Sydney Olympic Park New High School

SSDA Architectural Design Report

Amendment Report Addendum

Level 02 Floor Plan Comparison

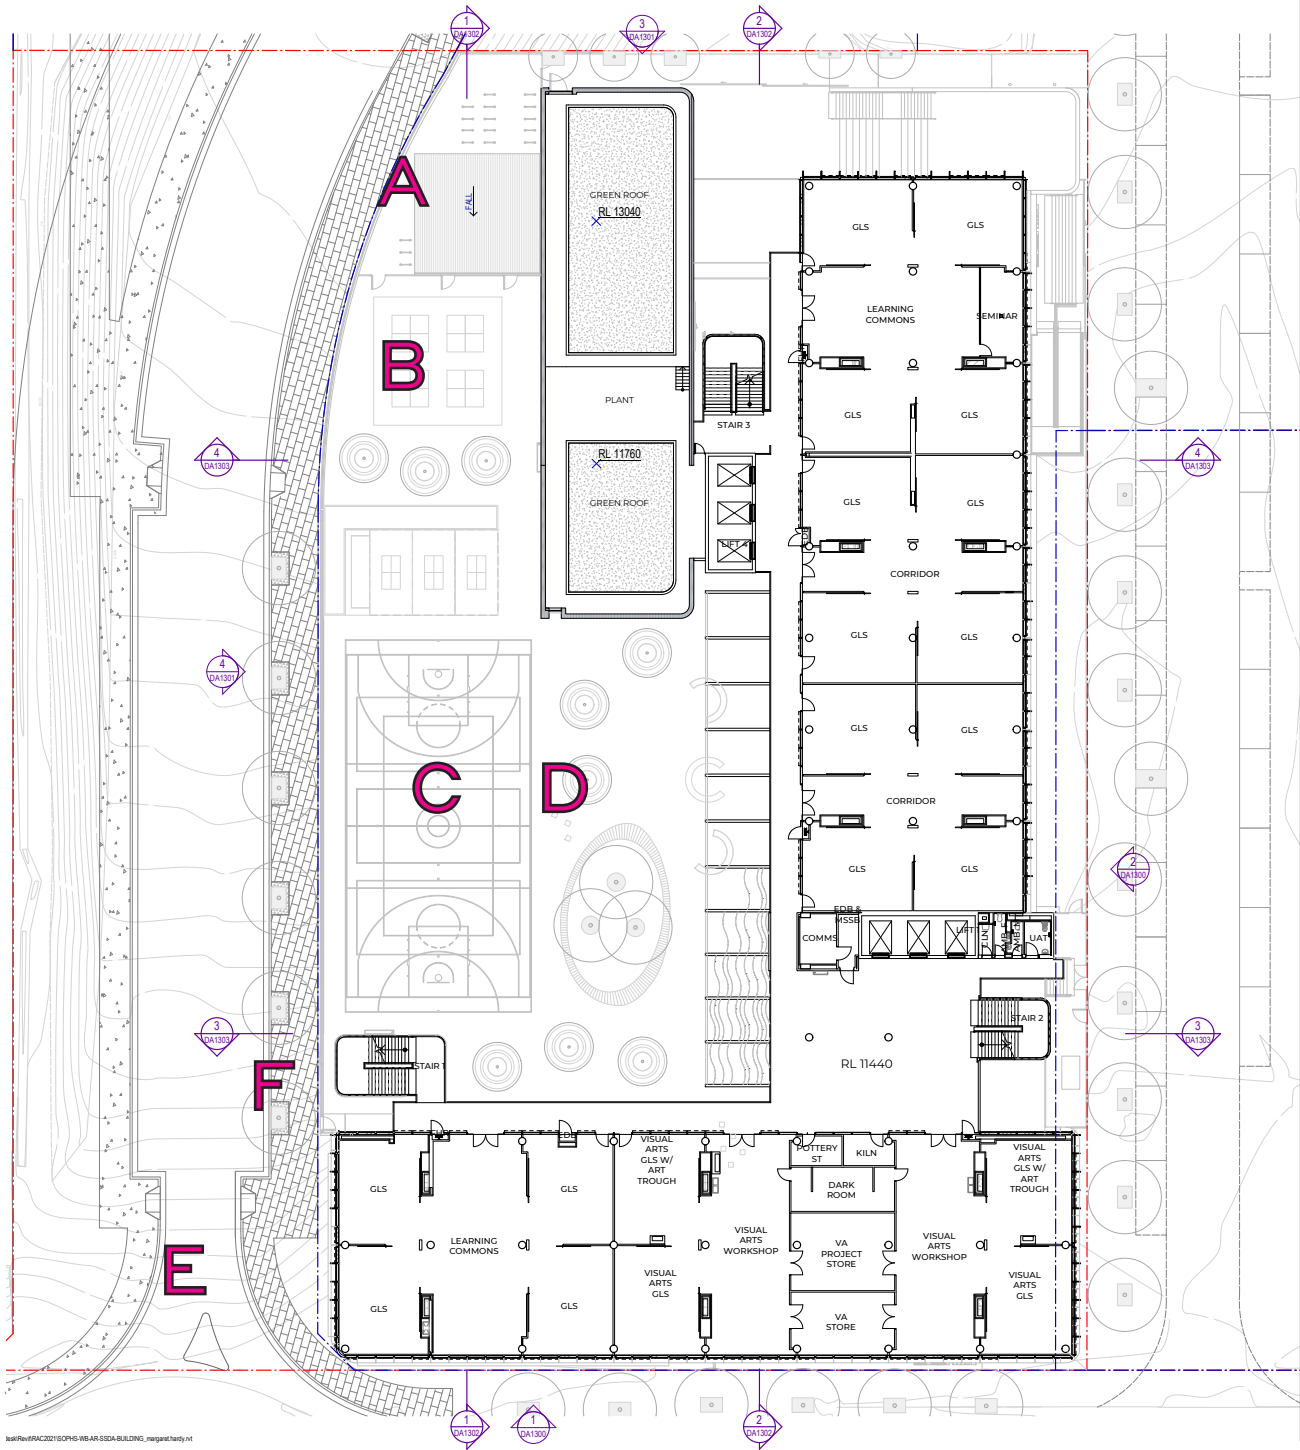
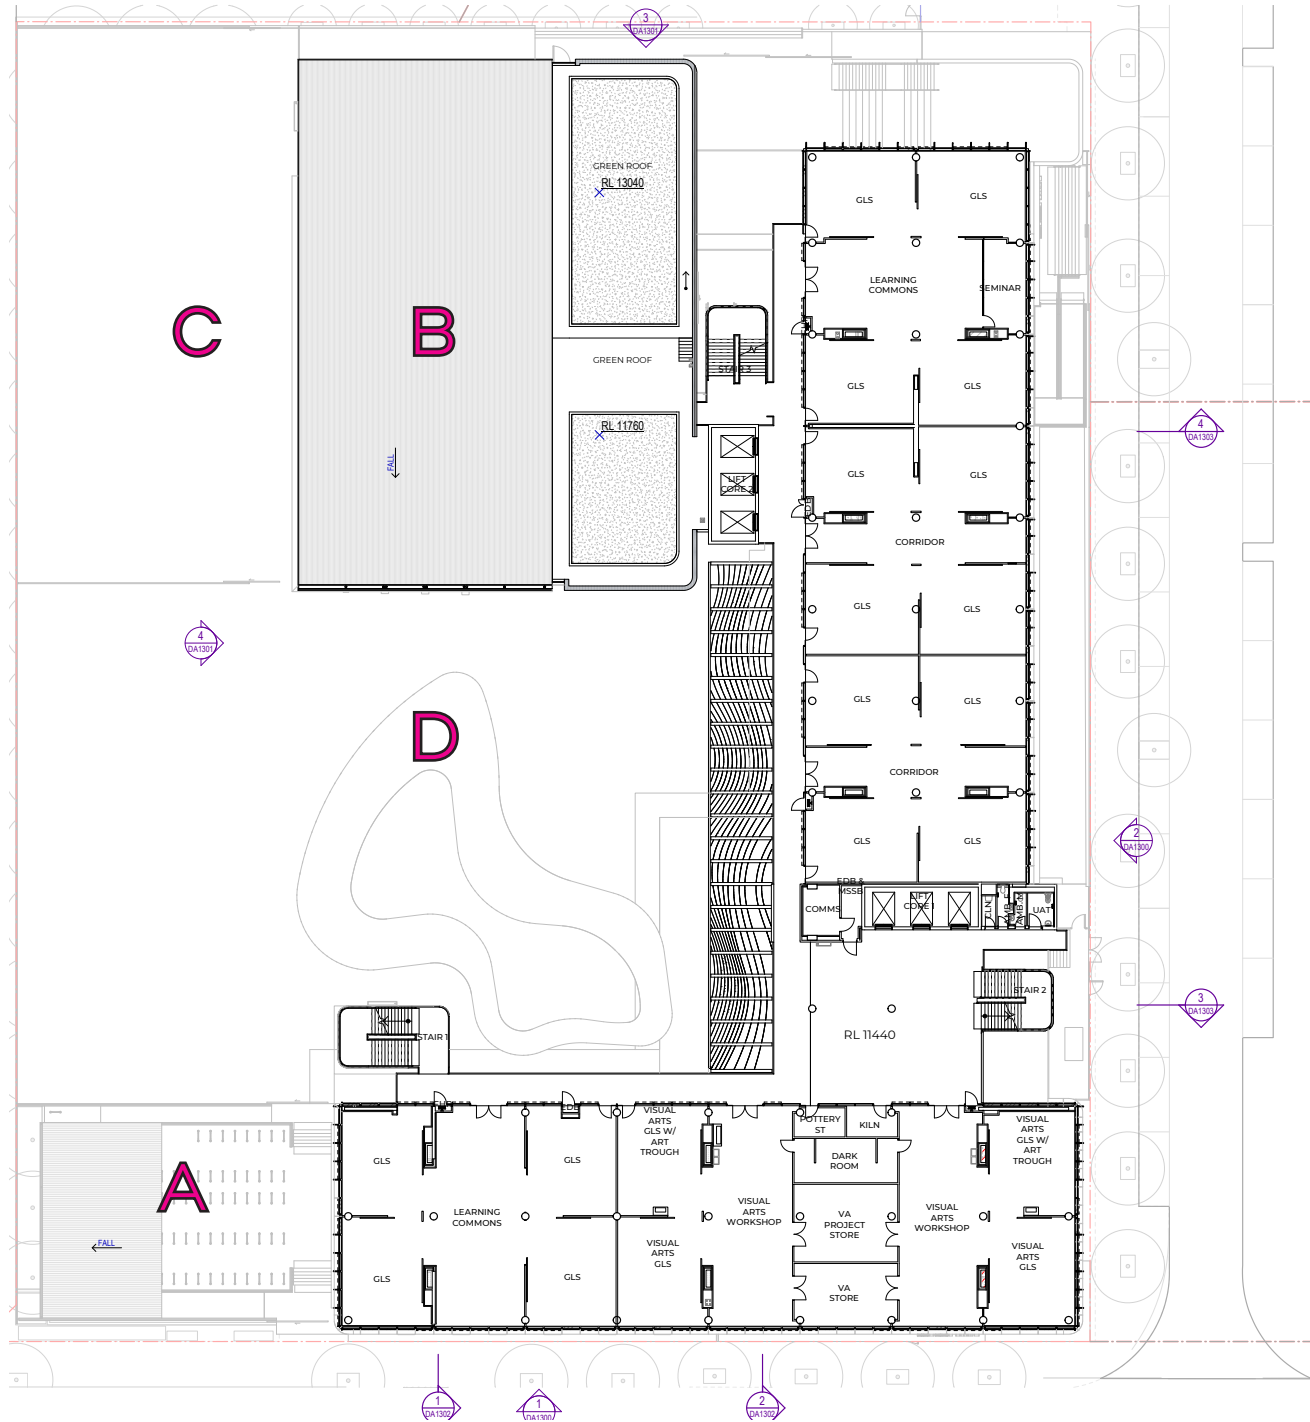
- A** Bike parking relocated
- B** Ground floor hall removed - relocated to Level 1
- C** External multi-purpose court - reduced to 1 and relocated
- D** Courtyard redesign, canopy omitted
- E** Ridge Road added
- F** Additional egress added to Ridge Road

Level 03 Floor Plan Comparison

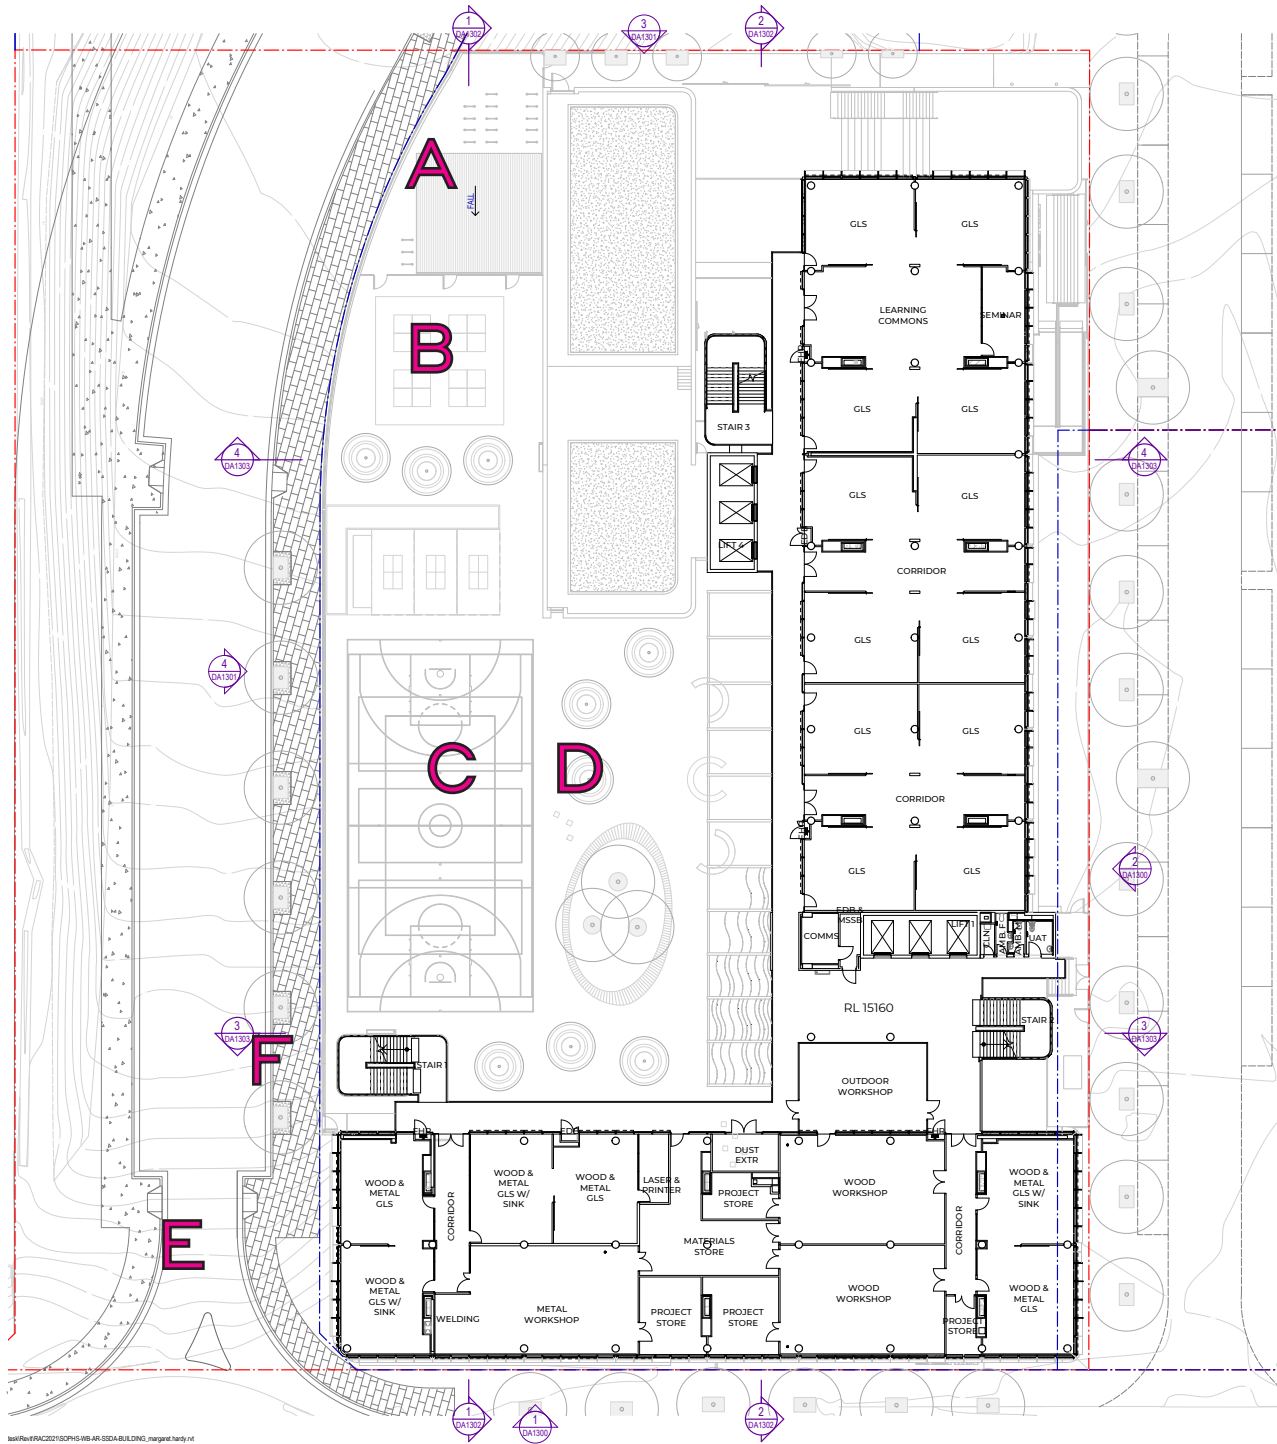
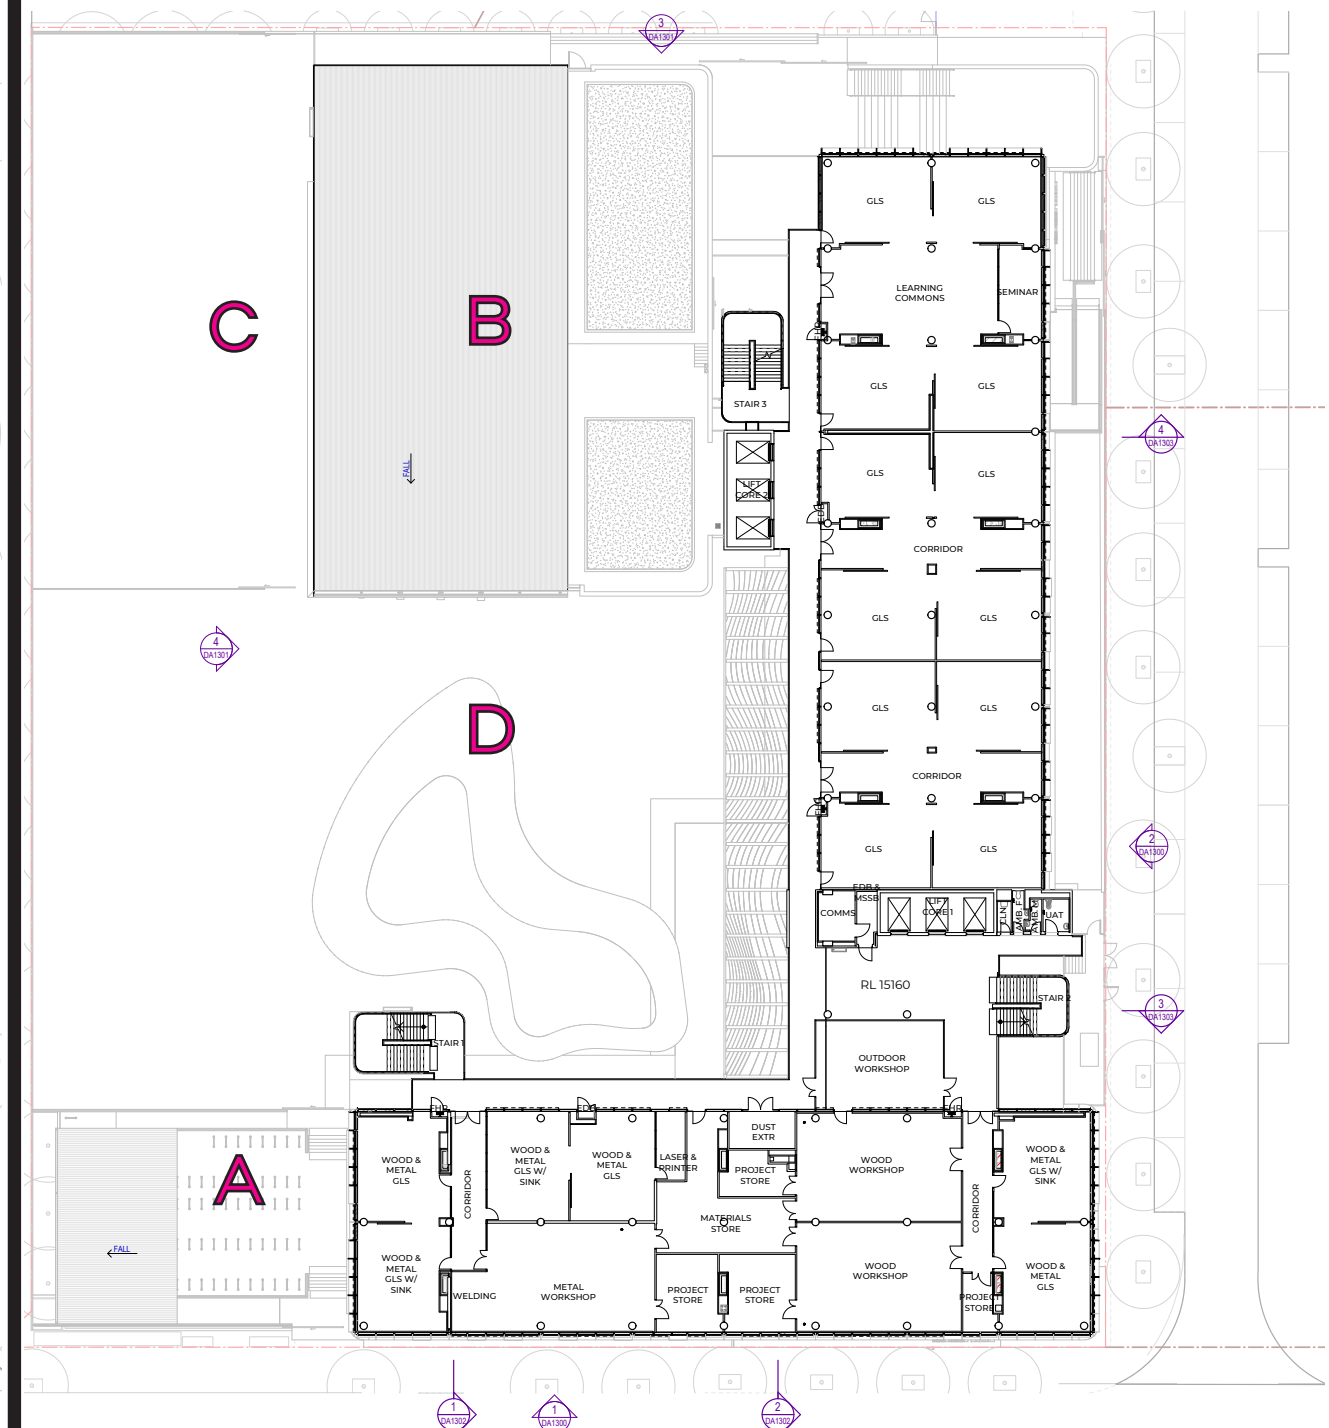
- A** Bike parking relocated
- B** Ground floor hall removed - relocated to Level 1
- C** External multi-purpose court - reduced to 1 and relocated
- D** Courtyard redesign, canopy omitted
- E** Ridge Road added
- F** Additional egress added to Ridge Road

Level 04 Floor Plan Comparison

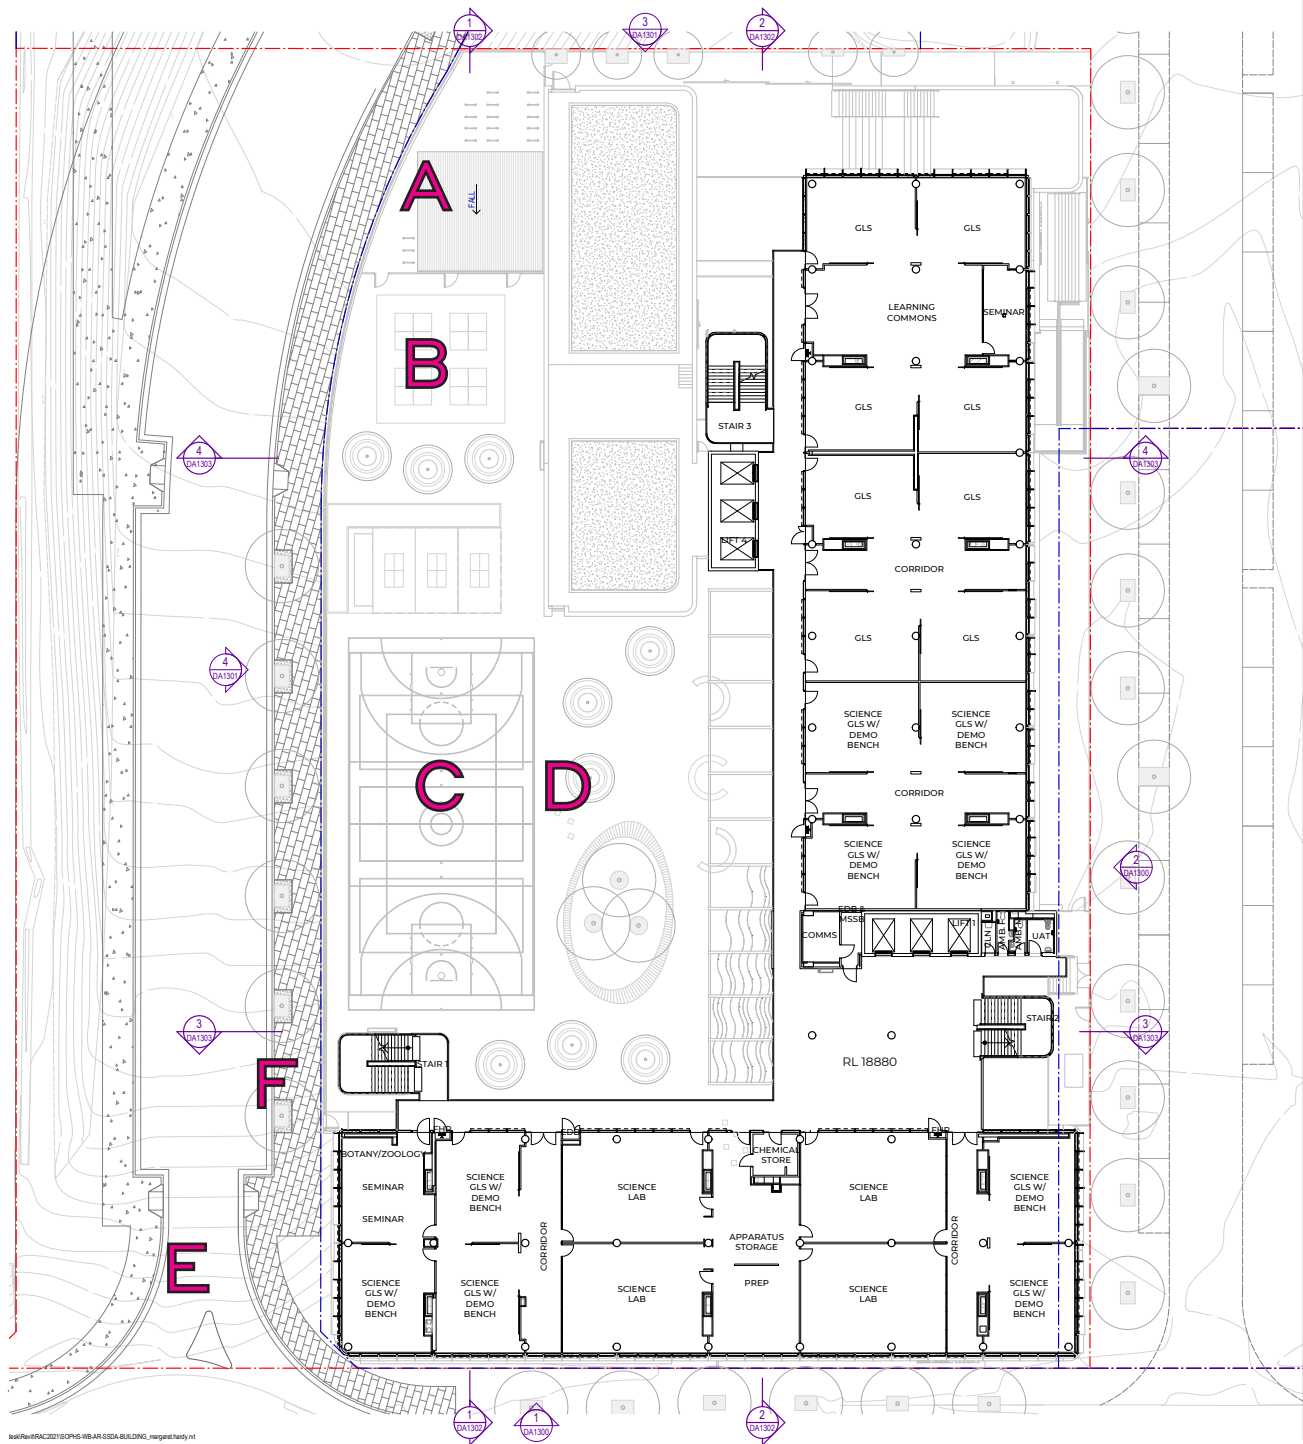
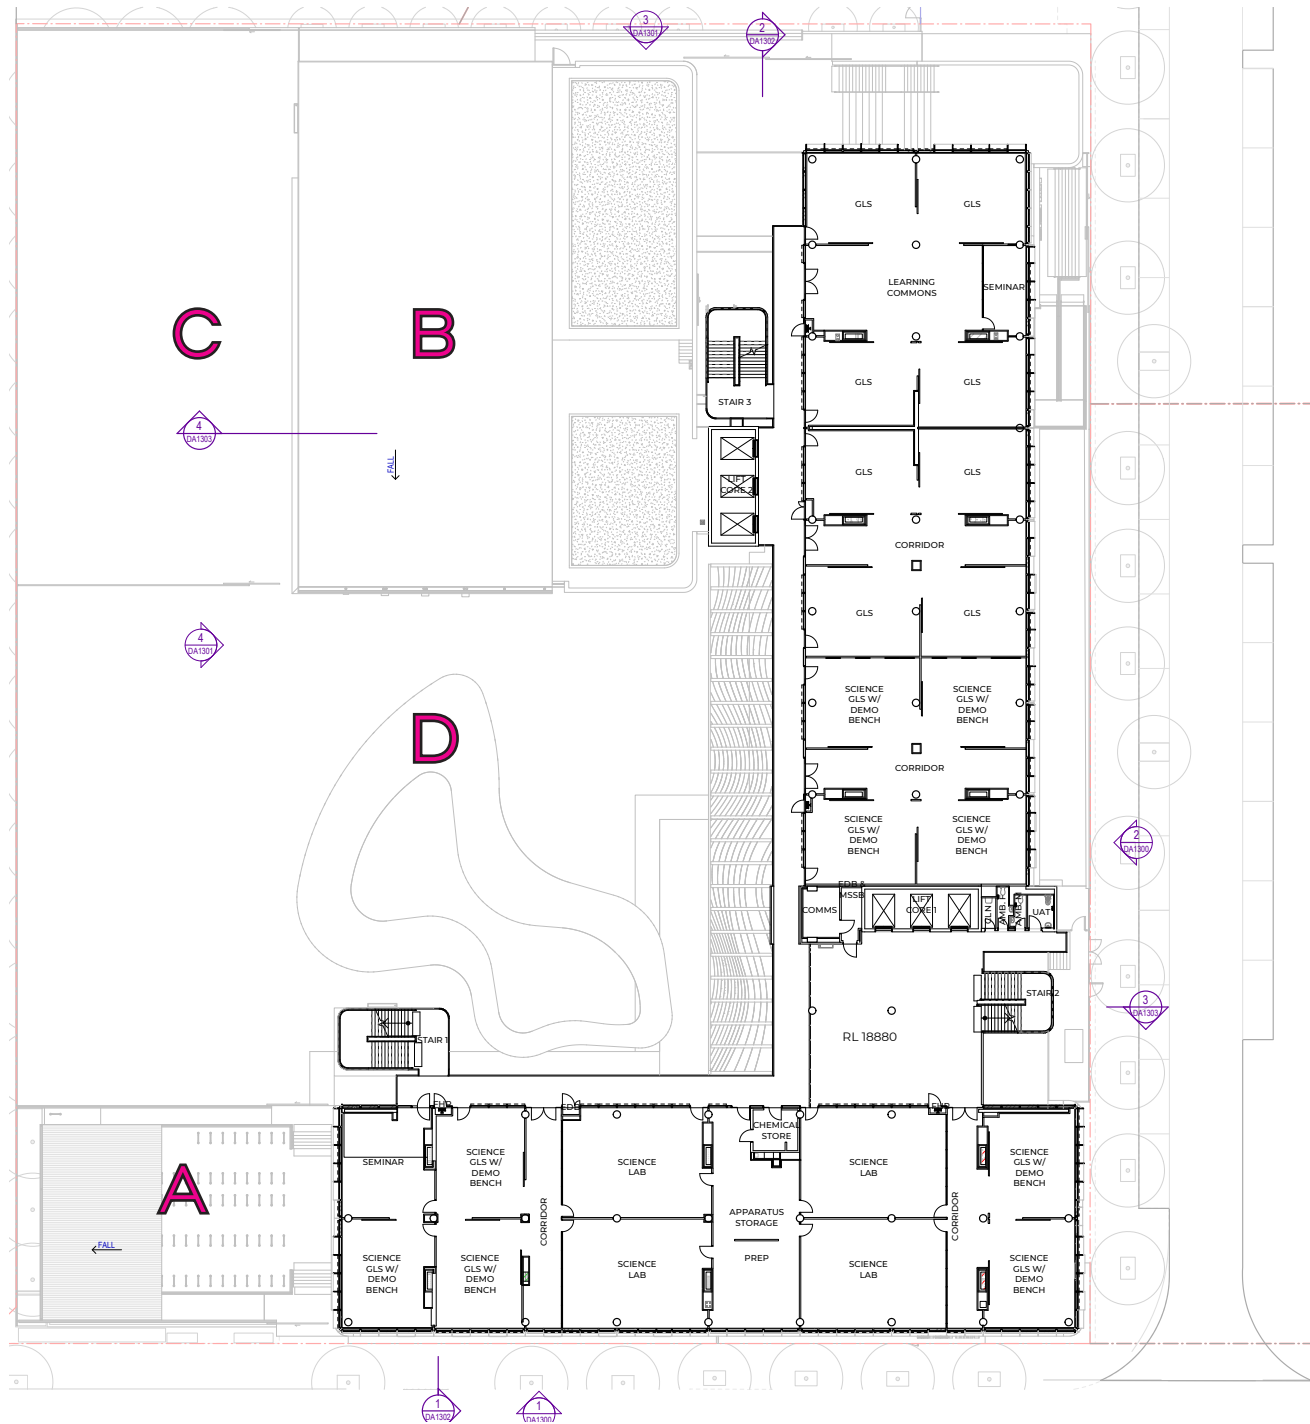
- A** Bike parking relocated
- B** Ground floor hall removed - relocated to Level 1
- C** External multi-purpose court - reduced to 1 and relocated
- D** Courtyard redesign, canopy omitted
- E** Ridge Road added
- F** Additional egress added to Ridge Road
